CASE COMMENT REPORT

CASE NO. UDP-S24024

| REQUEST: | Site Plan Level IV Review: 76-Unit Multifamily Residential Development with Building Height Exceeding 120 Feet and Five-Story Garage in the Central Beach Regional Activity Center |
| PROJECT NAME: | Ocean Park Residences |

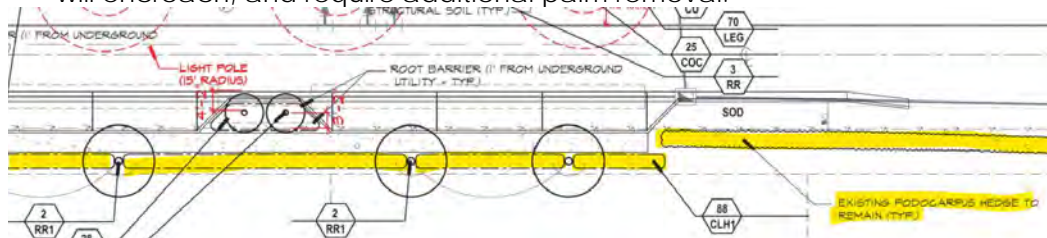
8. Illustrate and label the horizontal clearance from tree trunk to edge of utility on the landscape plan. Landscaping must provide a minimum horizontal clearance of 5 feet for small trees and palms, and a minimum of 10 feet for large trees and palms from underground utilities. Provide a cross section detail to

illustrate this clearance. Drainage line and wells proposed along north of project and shown in the sketch below is an example of a proposed conflict that needs to be shifted when in conflict with landscape.
